ARIZONA DEPARTMENT OF ENVIRONMENTAL QUALITY

Re: Mitigation Order, Docket No: P-50-06 – Review of Aquifer Characterization Report

The Arizona Department of Environmental Quality (ADEQ) has completed its review of the December 28, 2007 Aquifer Characterization report (ACR) submitted by Freeport MacMoRan Sierrita Inc. (Freeport). ADEQ has concerns about the ACR that are described in more detail in the attached comments, but the main concerns are as follows:

GENERAL COMMENTS

Approved KW	Date 11/29/07	Revised	Date	Reference: 7830166A	FIG. H.4b
----------------	------------------	---------	------	------------------------	--------------

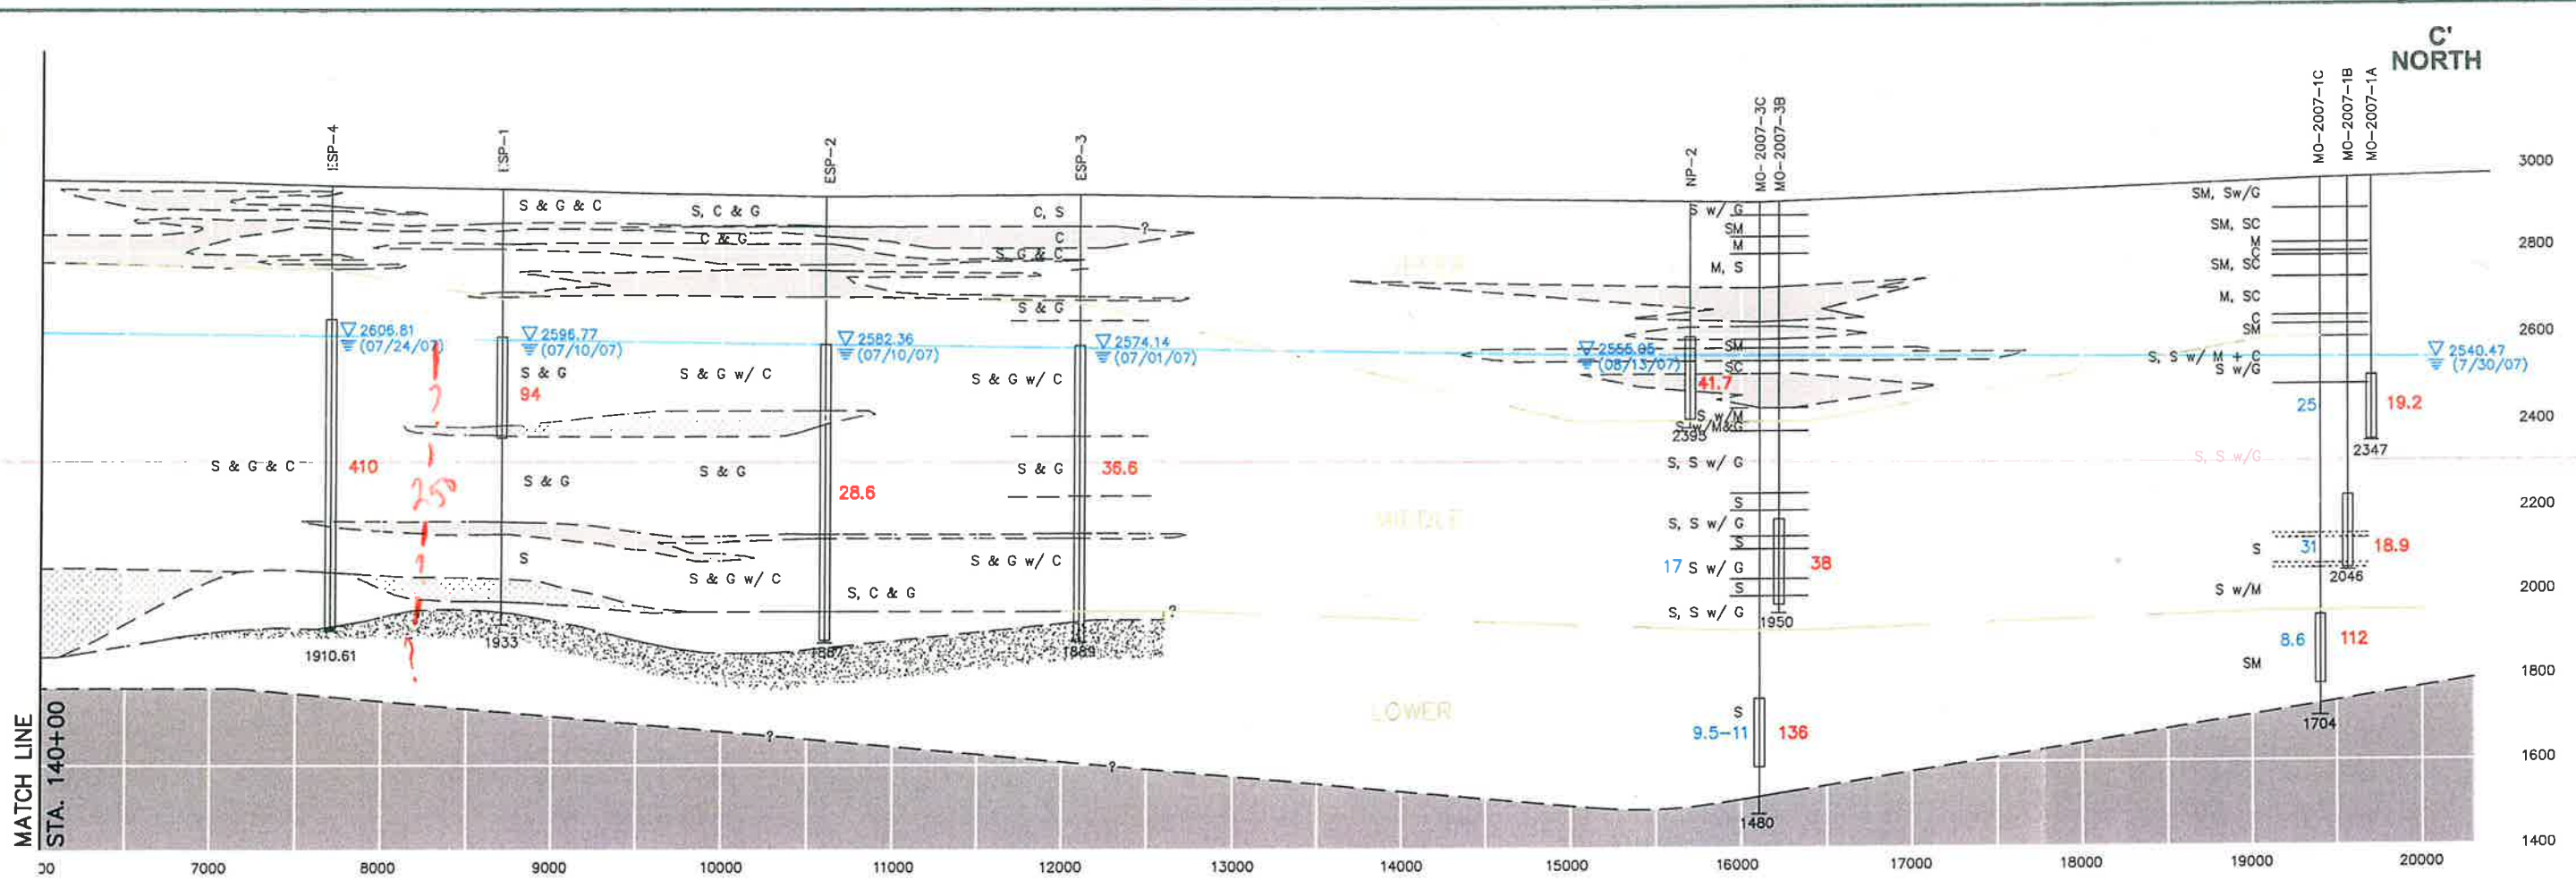
Freeport states in the last sentence of the first paragraph "*The contours on Figures 1 and 4 were developed using the highest measured sulfate concentrations at co-located wells,*" but the report does not provide a rationale as to why the highest concentration of sulfate was used. ADEQ believes it would be more informative to contour the sulfate data per potential hydrostratigraphic units. Freeport also should discuss the vertical distribution of sulfate within the basin fill aquifer, and include cross-sections that post and contour the sulfate data (See Attachments).

? - 1000 - Sulfate concentration contours queried where uncertain.

E - E' CROSS SECTION SHOWING WATER QUALITY AND HYDRAULIC CONDUCTIVITY DATA SIERRITA TAILING IMPOUNDMENT AREA			
	Approved KW	Date 11/29/07	Revised	Date
Reference: 7830167A		FIG. H.5

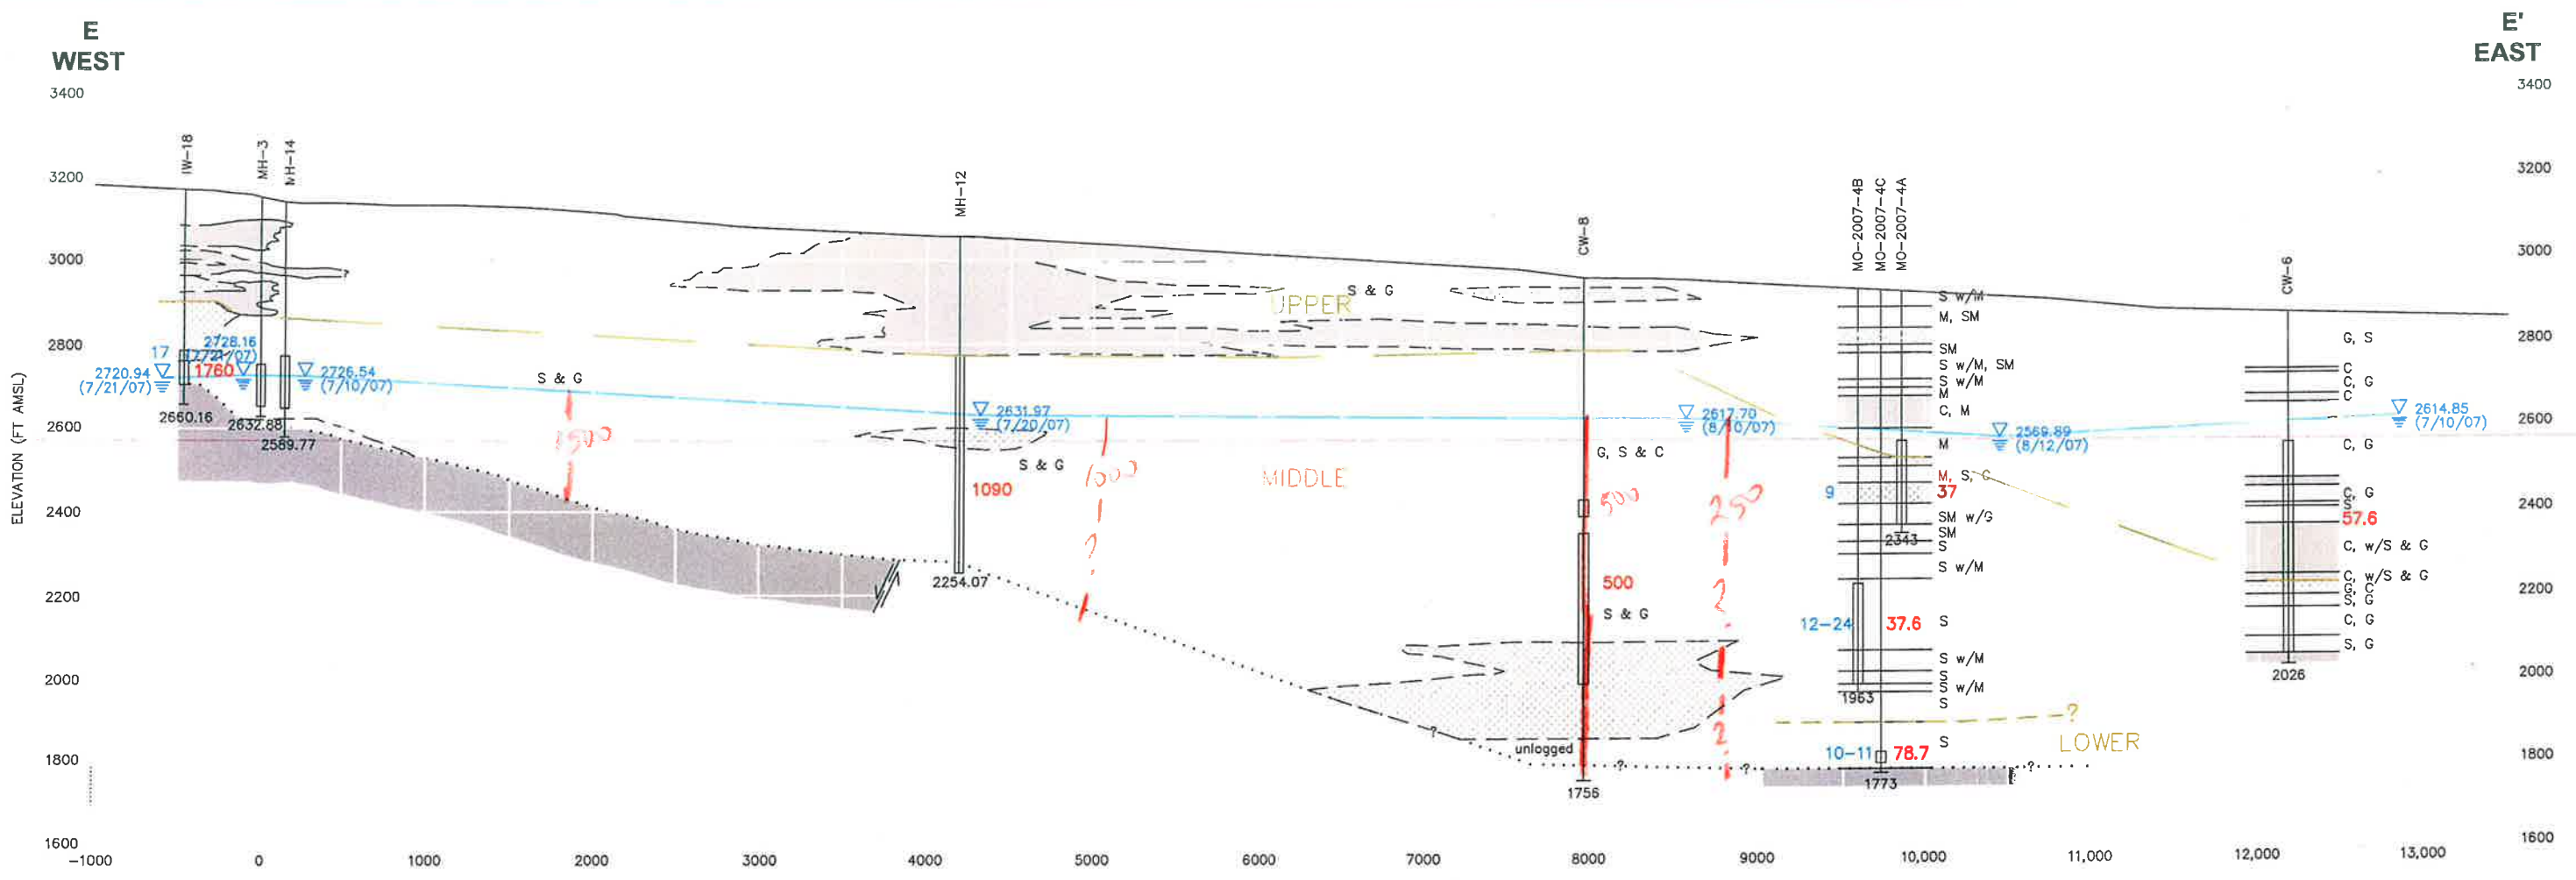
?-1000 - sulfate concentration control, queried where uncertain

F - F' CROSS SECTION SHOWING WATER QUALITY AND HYDRAULIC CONDUCTIVITY DATA SIERRITA TAILING IMPOUNDMENT AREA			
	Approved KW	Date 11/29/07	Revised	Date
Reference: 7830168A				FIG. H.6

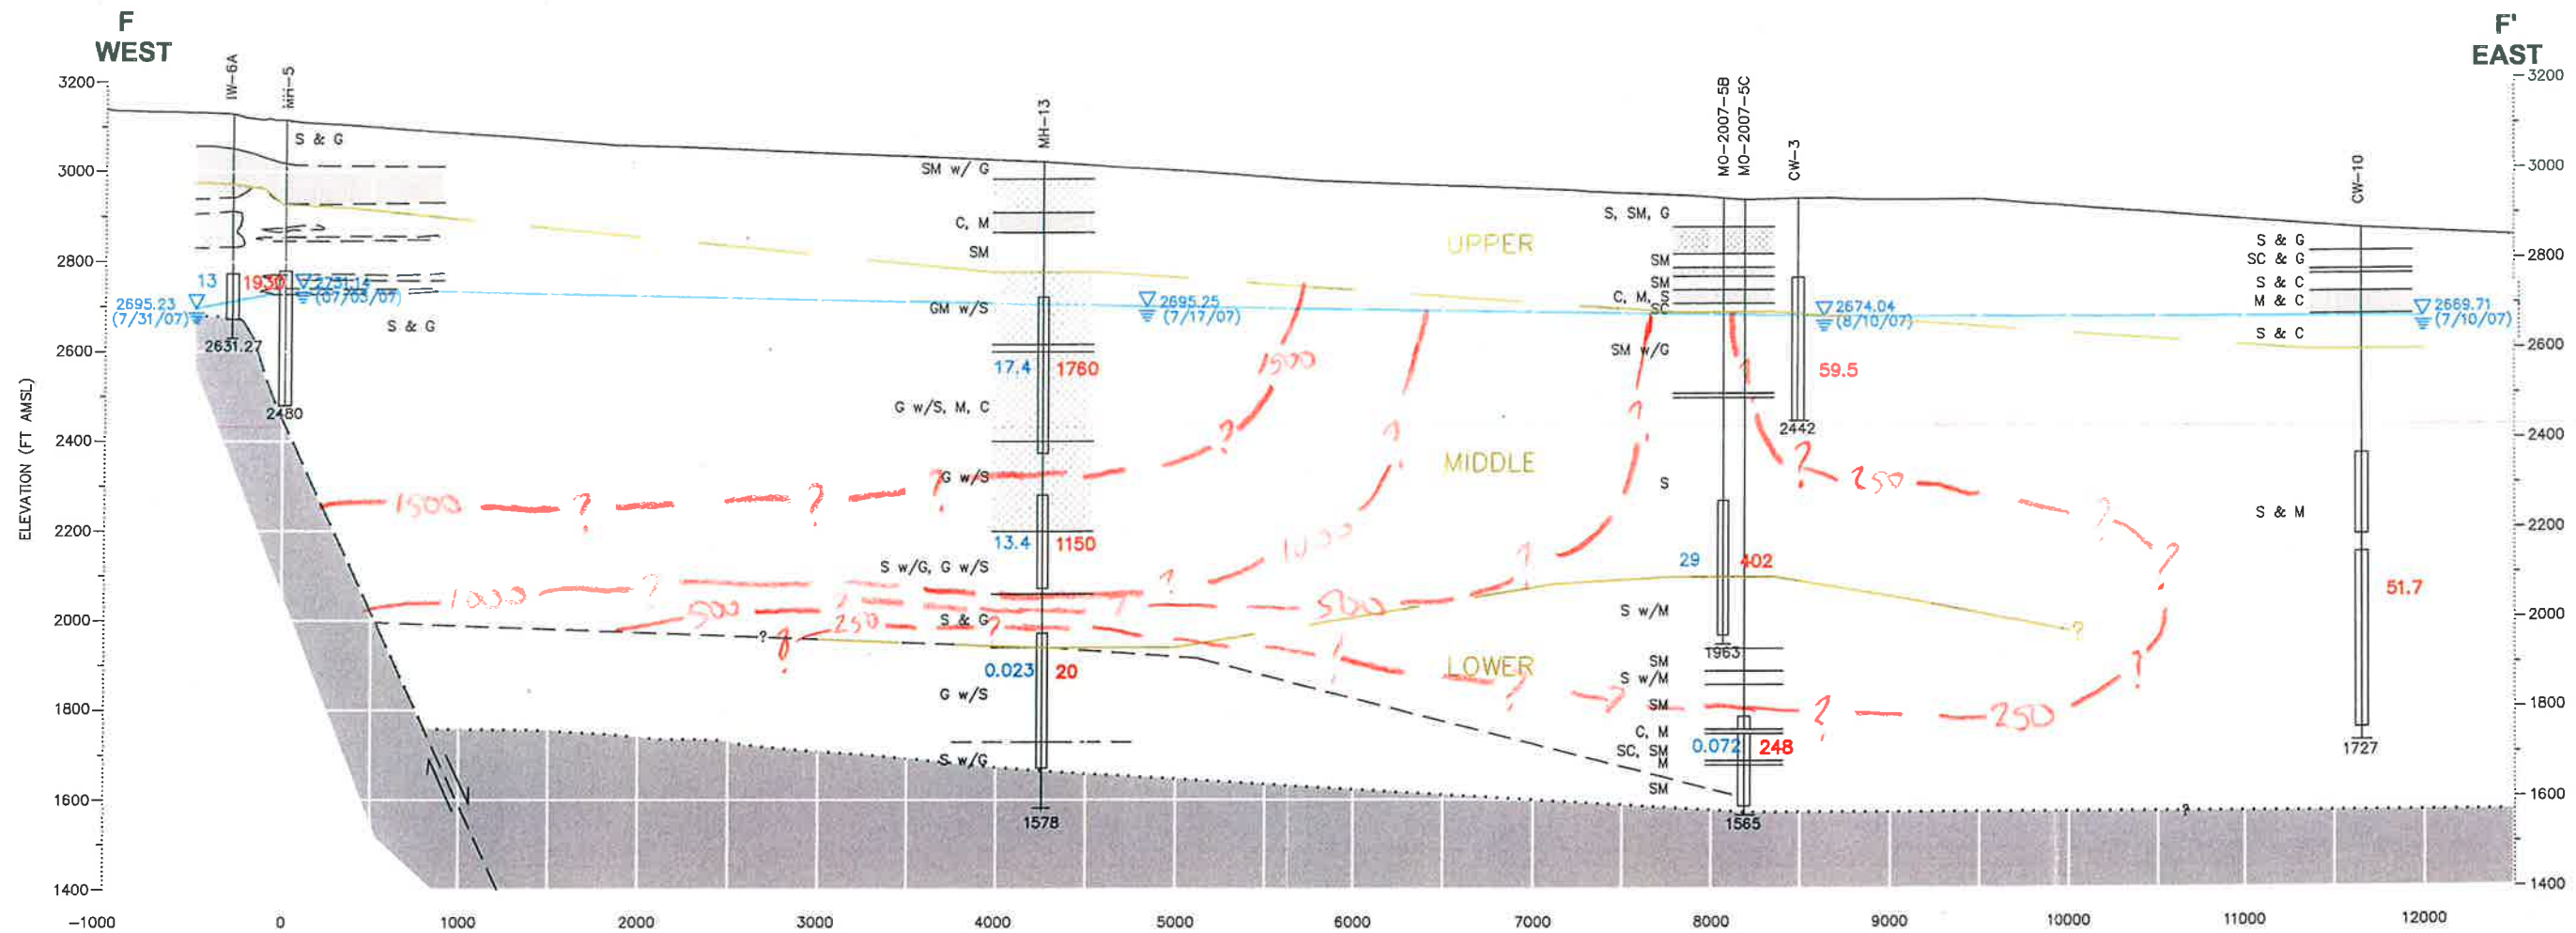
1,700 mg/L
 ? - 1000 - sulfate concentration contours, queried where uncertain

H - H' CROSS SECTION SHOWING WATER QUALITY AND HYDRAULIC CONDUCTIVITY DATA SIERRITA TAILING IMPOUNDMENT AREA

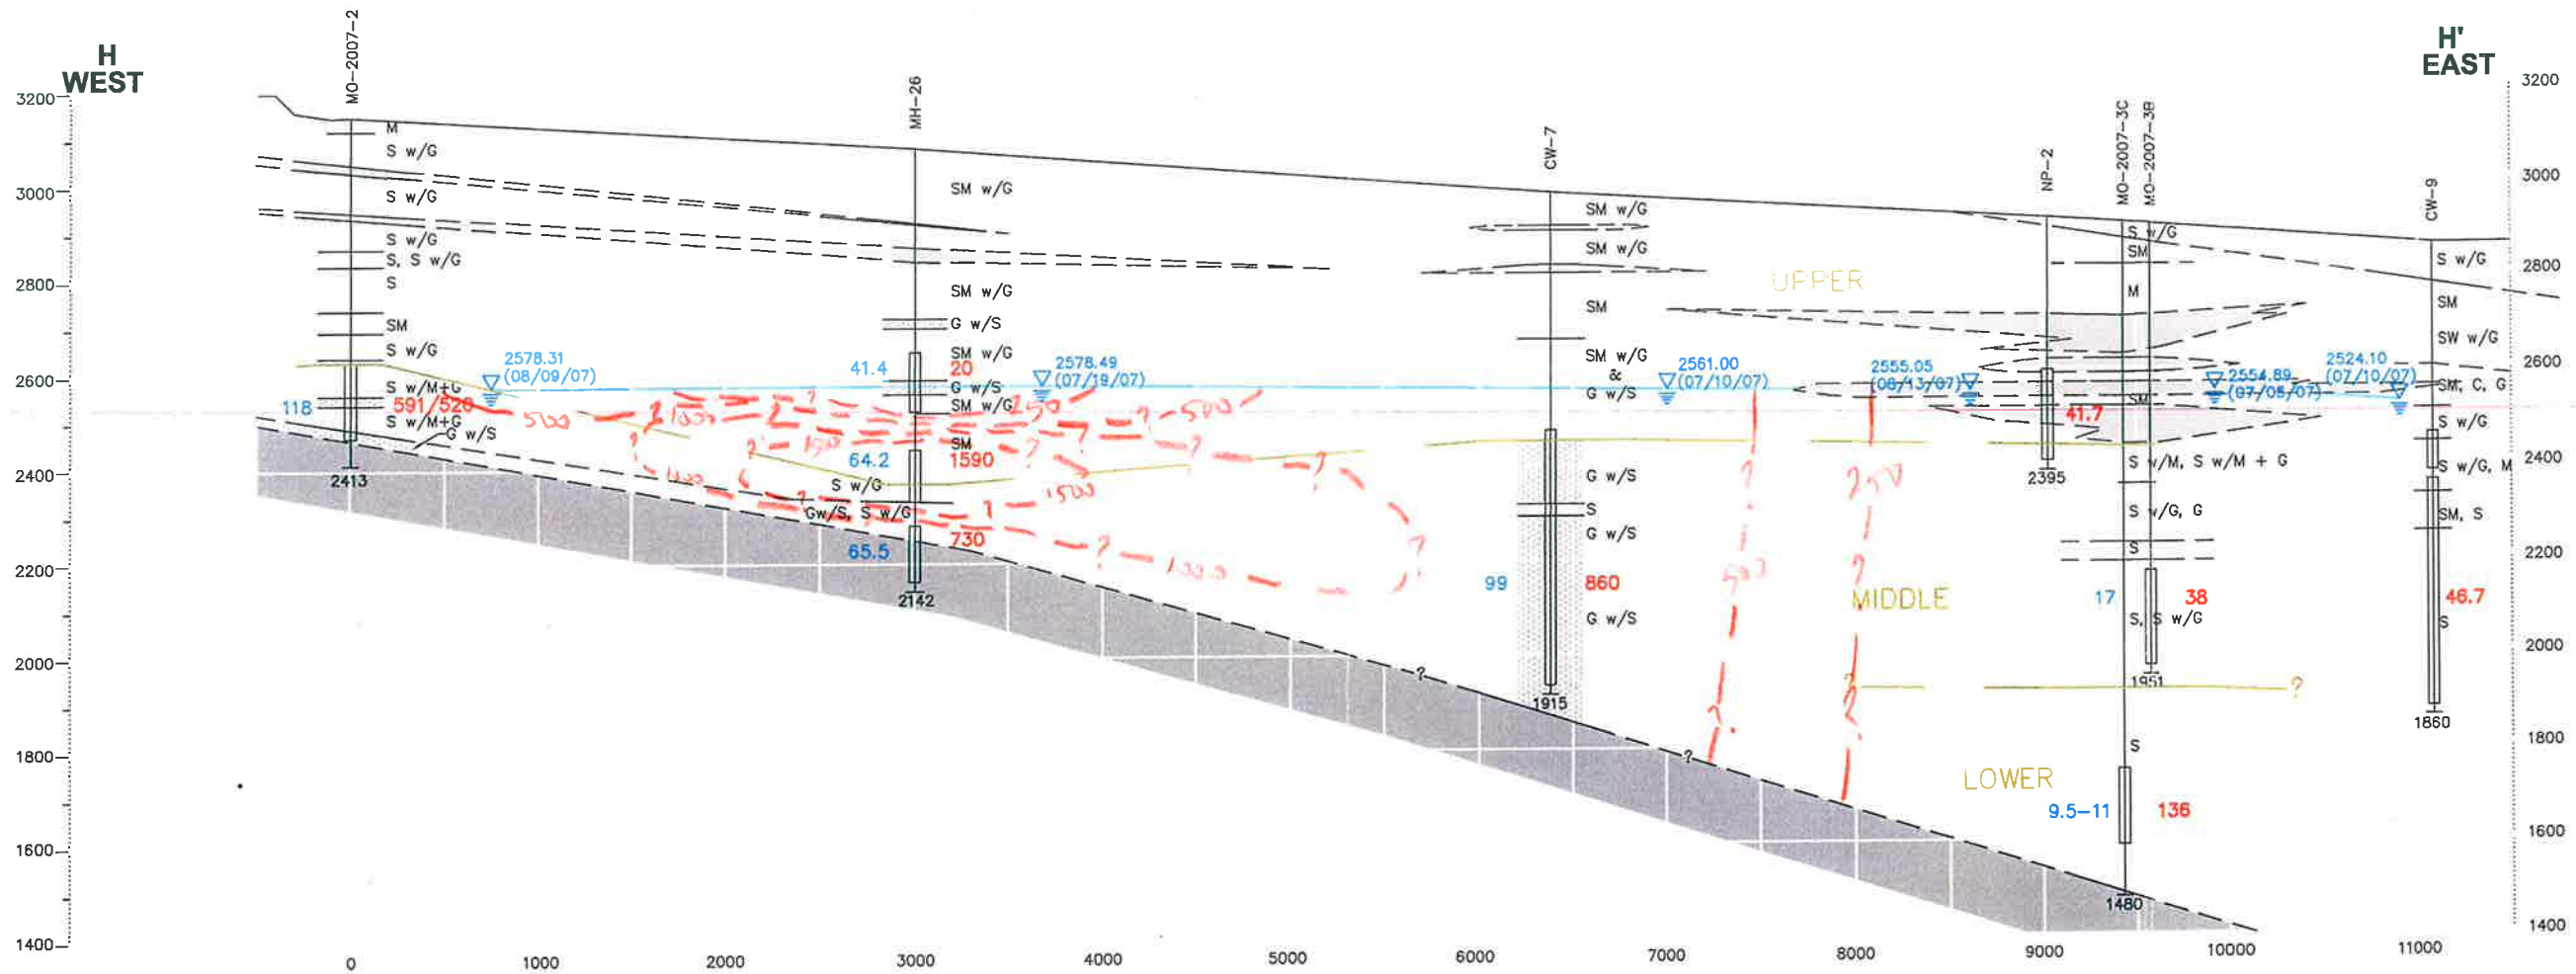
? - 1000 Sulfate concentration contours, queried where uncertain
